# NGC Base HV Breakdown Study

D. Mack

9/20/21

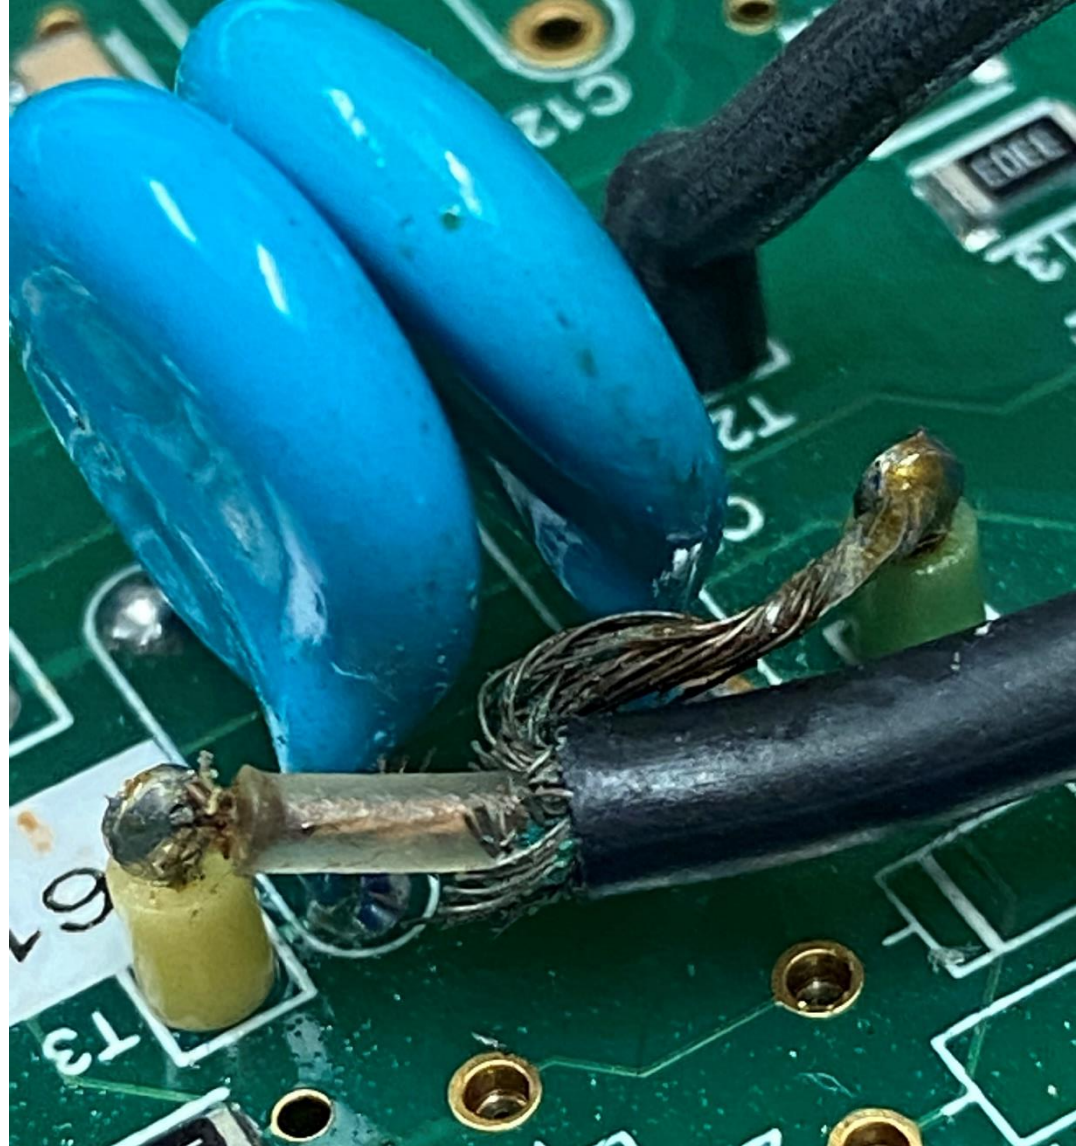
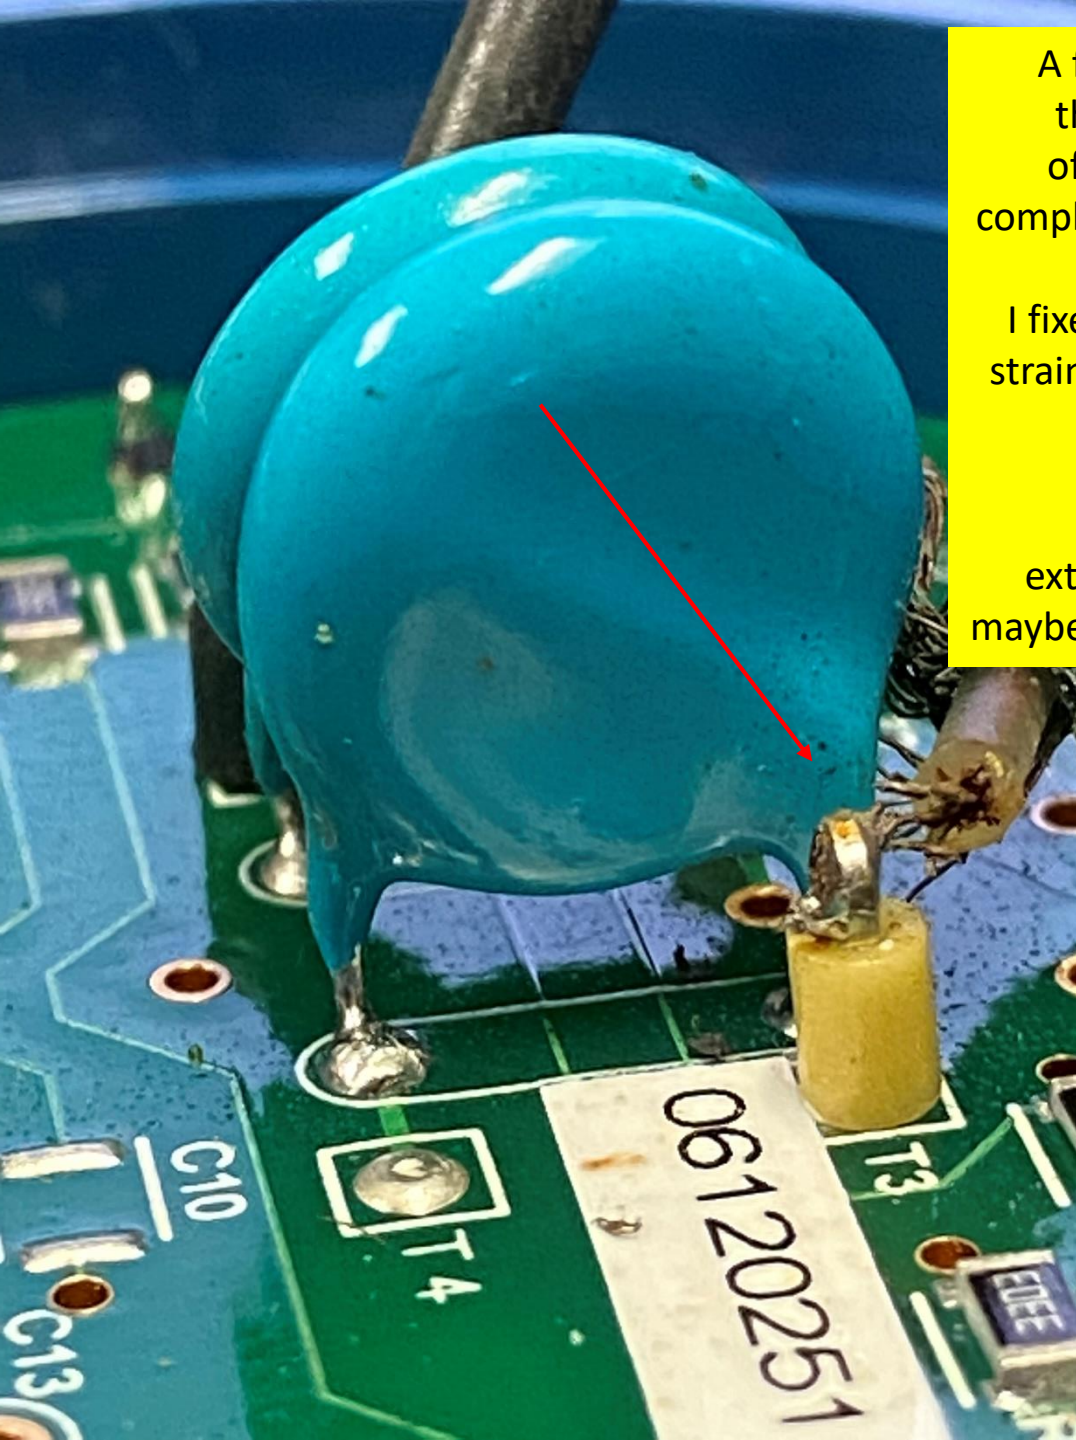
(in hindsight, to get this shot, I'm all but breaking off the signal connection)

In a brief test at 2300V in air, I could not make this base spark. That's expected, since an air gap would have to drop to only ~2mm to start sparking infrequently.

But these stray ground braid wires are the kind of variable that could cause some bases to have less than 4mm gap and maybe start sparking in a Neon-rich atmosphere.

A few cable wiggles later, the few copper strands of the signal connection completely broke from the post.

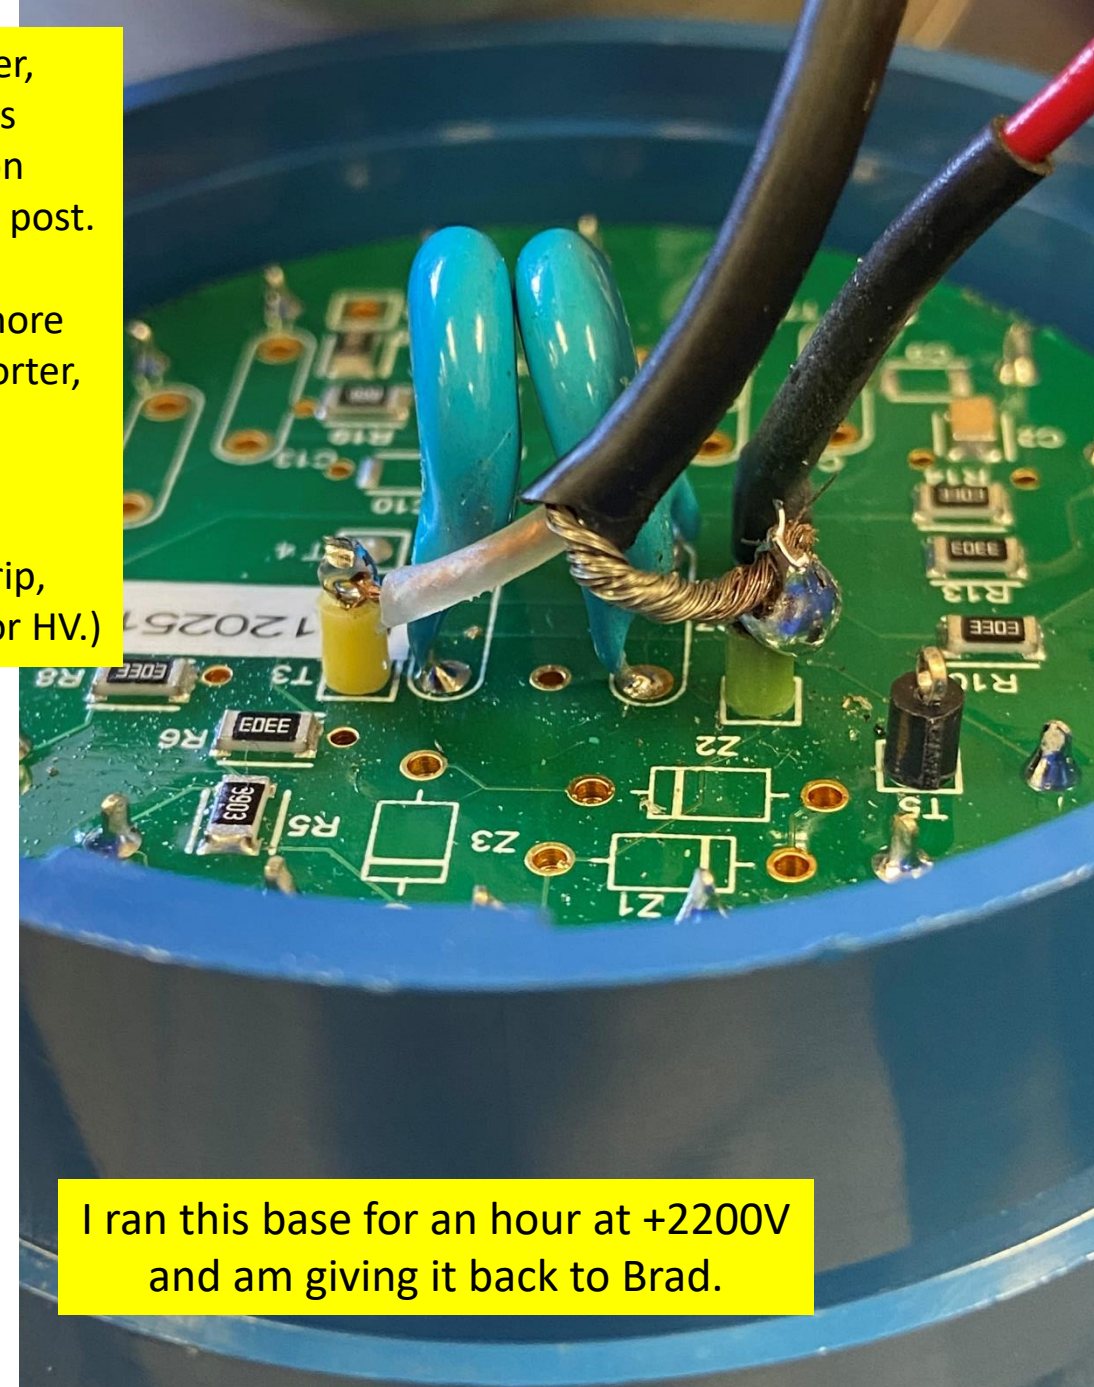
(The black cable is extremely difficult to strip, maybe because it's rated for HV.)

I fixed it, arguably with more strain relief and fewer, shorter, sharp wire points.

I ran this base for an hour at +2200V and am giving it back to Brad.
